**CONCRETE STRUCTURES STANDARD**  
**Part 1**  
**THE DESIGN OF CONCRETE STRUCTURES**

**AMENDMENT NO. 1**

December 1998

CONCRETE STRUCTURES STANDARD  
Part 2  
COMMENTARY ON THE DESIGN OF CONCRETE STRUCTURES

**Figure 6.3** (page 66)

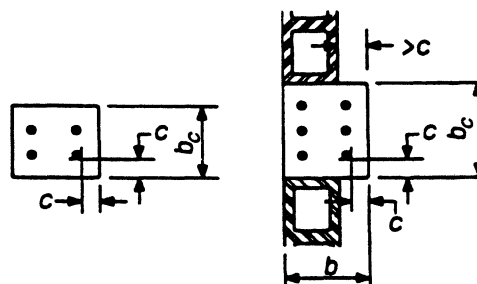
**Delete** top part of the figure and **substitute** the following:

(Changes: Dimension  $b$  changed to  $b_c$  in two places.)

**Figure C8.7** (page 120)**Delete** figure and **substitute**:

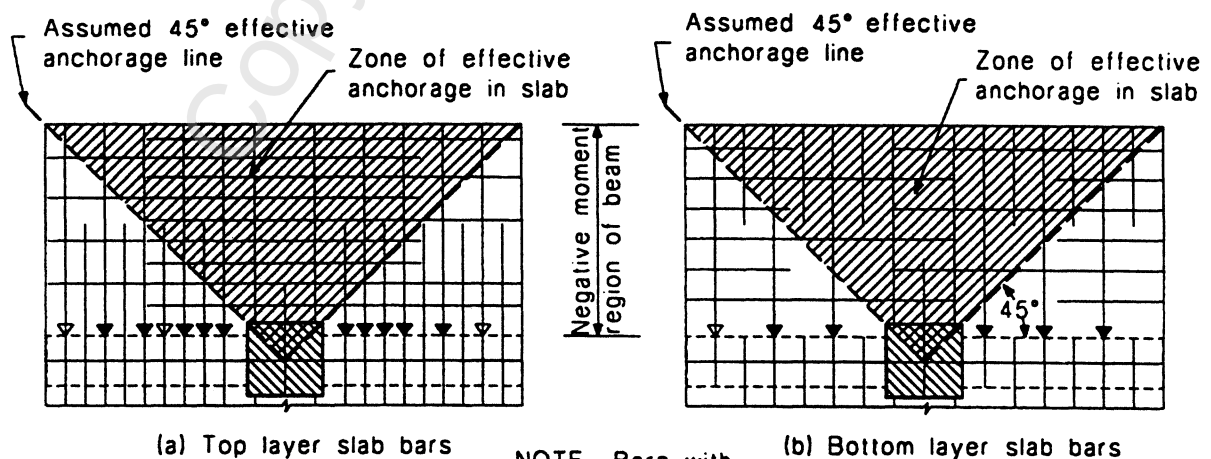
(Changes: Bar termination removed from centreline B. Flexural capacity required lines and tension shift added. Note added.)

NOTE – Tension shift: accounts for the actual tension force in the flexural reinforcement, at a given section, being greater than that required to resist the bending moment at that section; being a function of the slope of the inclined crack or diagonal compression (typically assumed to be  $45^\circ$ ), which is part of the truss mechanism that resists shear<sup>8.1</sup>.

**Figure C8.10** (page 124)**Delete** figure C8.10 and **substitute** the following:

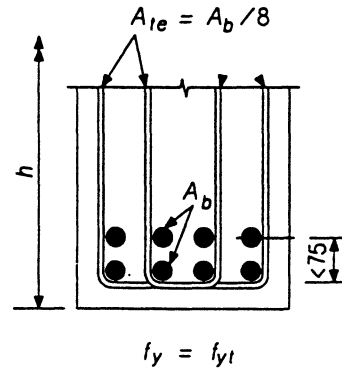
(Changes: Bars with full and partial anchorage in (a) changed.)

NOTE – Bars with:  
 ▼ full anchorage  
 ▽ partial anchorage

**Figure C8.11(b)** (page 125)**Delete** part figure and **substitute**:

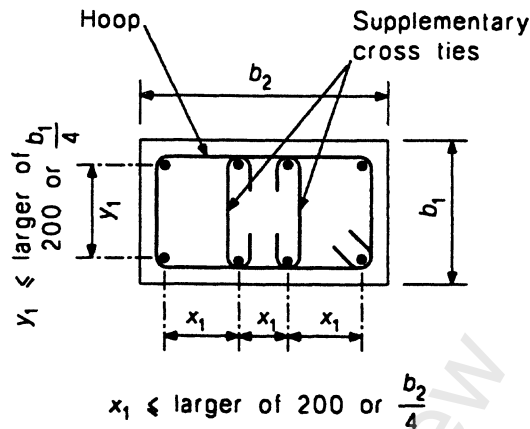
(Change: Dimension &lt;75 taken to inside face of stirrup tie.)

**Delete** the caption and **substitute**:**"Figure C8.11 - The arrangement and size of stirrup-ties spaced at  $6 d_b$  between centres in plastic hinge regions."**

**Figure C8.12(a)** (page 130)  
**Delete** the figure and **substitute**:

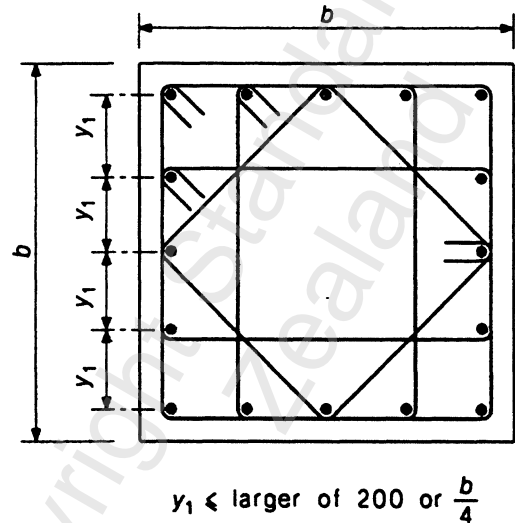
(Change: Dimension  $x_1$  and  $y_1$  taken to centrelines of longitudinal bars.)

**Figure C8.13(b)** (page 131)  
**Delete** part figure and **substitute**:

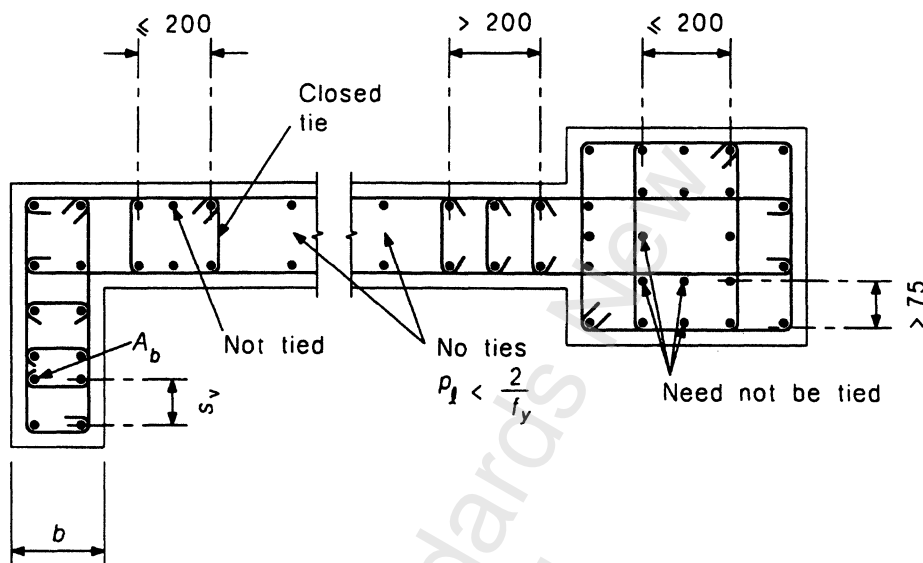
(Change: Dimension  $b$  to face of member, dimension  $y_1$  to main bar centres.)
